### **THAMES WATER RESPONSE TO COUNCIL SCRUTINY RECOMMENDATIONS**

Thank you for the invitation to speak at the Royal Borough of Kensington and Chelsea's Public Realm Scrutiny Committee meeting on 23<sup>rd</sup> July 2019 and your subsequent letter dated 1<sup>st</sup> August 2019.

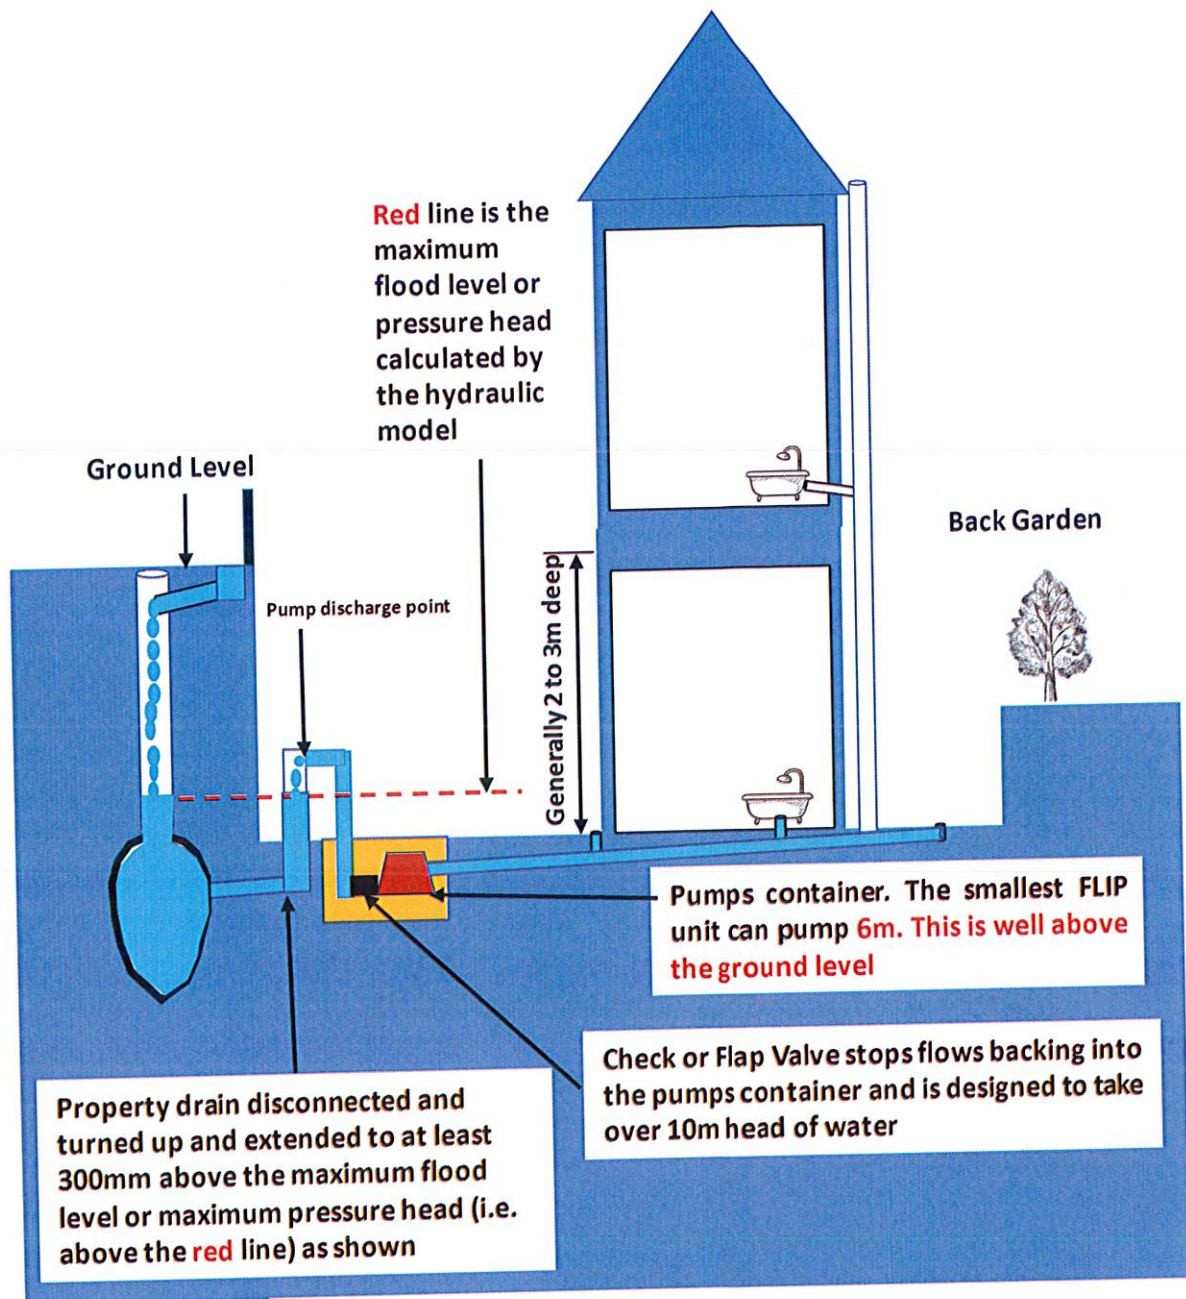
5. Thames Water to provide data of a technical nature on the levels of water pressure the FLIP devices and non-return valves could cope in storm events (1 in 30yrs, 1 in 40yrs, 1 in 50yrs events);

At the meeting there seemed to be some confusion in respect of the way FLIP devices operate. The diagram and the explanation on the following two pages should help to clarify this matter.

- The red line on the diagram indicates the maximum anticipated design water level (or static pressure) in the sewer. The level of the red line is calculated using the hydraulic model based on a rainfall intensity of 1 in 30yr return period plus an allowance for climate change. **Based on the hydraulic model, in this catchment, the red line is generally below the ground level but above some of the basement levels.**
- The connection pipework from the property into the basement is disconnected and taken above the red line as shown in the above sketch.
- The FLIP device pumps the flows higher than the red line. As you can see from the above diagram the pump discharge point is higher than the red line by a minimum of 300mm.
- Therefore, as you can see, the flows from the sewer cannot back into the FLIP device.

- If a more intense rainfall than 1 in 30yr return period is experienced and the red line (or pressure) rises, then the flows can back into the FLIP device, but the Check or Flap Valve shown on the above diagram would prevent the flows entering the pumps container.
- **The smallest FLIP device can pump to a head of 6m.** The basements are approximately between 2 and 3m deep, therefore the pumps can pump to a level well above the red line and also well above the ground level. This means that even under the extreme circumstances of the rainfall intensity exceeding 1 in 30yr return period, the pumps can continue to pump the flows through the Flap Valve into the sewer. **The Flap Valve can take pressures higher than 10m which is again well above the red line and ground level.** Below is a web link to the FLIP supplier's Technical Data Sheet (Compli 1000 range):

- For rare rainfall events such as a 1 in 40 or even 1 in 50yr return period, the FLIP devices will continue to prevent sewage flooding, but please remember that the gullies in the road (which are the responsibility of the Highway Authority) are unlikely to be able to cope with such large rainfall events. This means that the surface water run-off will not be able to enter the sewer system and will therefore flood the highways. The surface water from a flooded highway may lead to over-land flooding impacting the light wells leading to basements, possibly resulting in basement flooding. This kind of flooding is not caused by the sewer but short-comings in the capacity of surface drainage such as highway drainage.

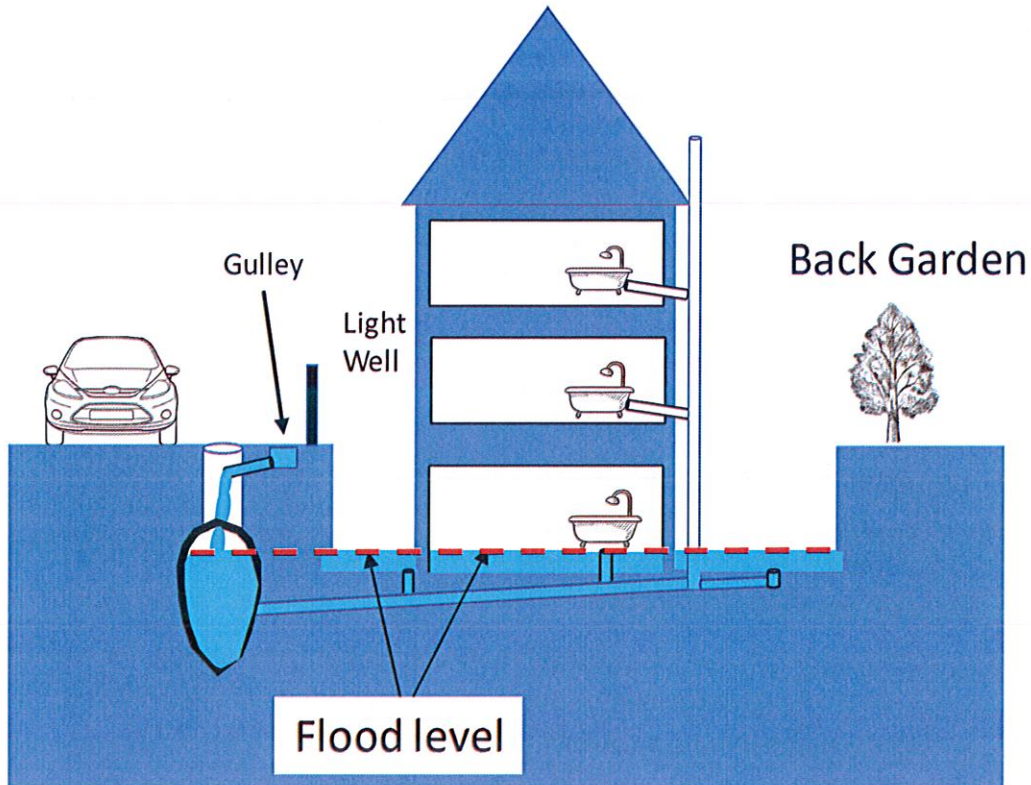
At the meeting concern was expressed about the robustness of FLIPs as a solution, seeing them as more of a short-term solution to localised basement flooding. A statement by Thames Water in relation to its previous proposal of constructing a storm relief sewer was read out. In the statement Thames Water had indicated that FLIPs do not address the surcharge within the sewerage system and that a storm relief sewer, as a long-term solution, was required.

many basements were as deep as the local sewer in the road. Therefore, in intense rainfall, the flows could back up from the local sewers into the basements irrespective of the operation of any Storm Relief Sewer. The diagram below should help to better demonstrate this critical point:

- The flood level is indicated in red. We found that at many locations the basements were at a similar level to the sewer. As you can see this means that water can back up into the basement before the sewer is full.

- To prevent flooding, the flows had to be diverted from the local sewers to lower the red line. This would have resulted in extensive works being implemented whilst our assets were not even at full capacity.
